AGENDA
JACKSON MUNICIPAL REGIONAL PLANNING COMMISSION
CITY HALL – GEORGE A. SMITH MEETING ROOM
FIRST FLOOR – 109 EAST MAIN STREET – SUITE 107
MAY 5, 2021 – 3:00 P.M.

MINUTES
JACKSON MUNICIPAL REGIONAL PLANNING COMMISSION
CITY HALL – GEORGE A. SMITH MEETING ROOM
FIRST FLOOR – 109 EAST MAIN STREET – SUITE 107
APRIL 7, 2021—3:00 P.M.

SITE PLAN STAFF REPORT Chic-Fil-A

SITE LOCATION MAP
JACKSON SOLAR MICROGRID SITE PLAN - ROOSEVELT PARKWAY

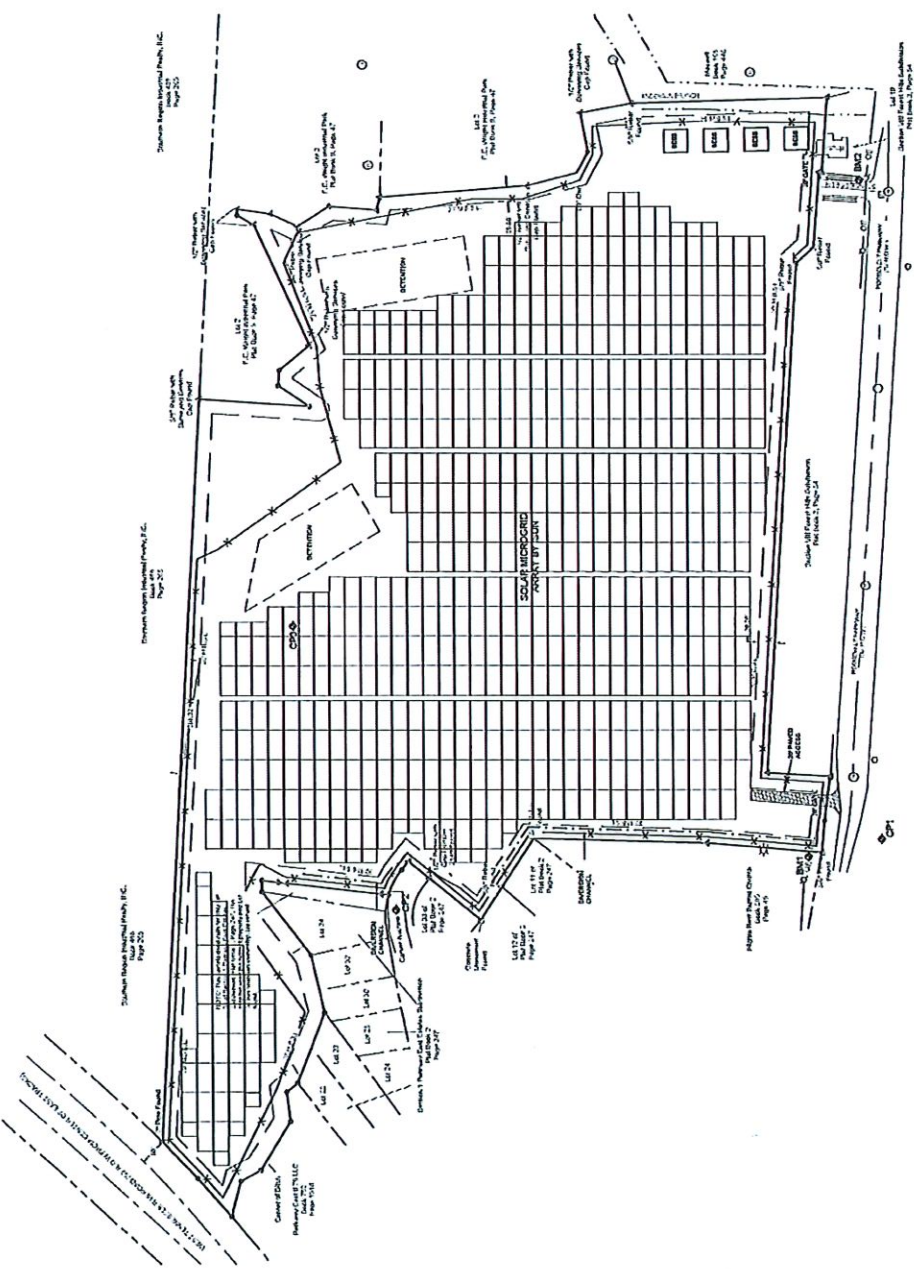
- 1) A decommissioning plan, along with a reclamation guaranty, be submitted and approved by Planning Staff prior to permitting; and
- 2) The slatted fence, buffer landscaping, and replacement trees must be maintained, and replaced when necessary, for the full life of the project.
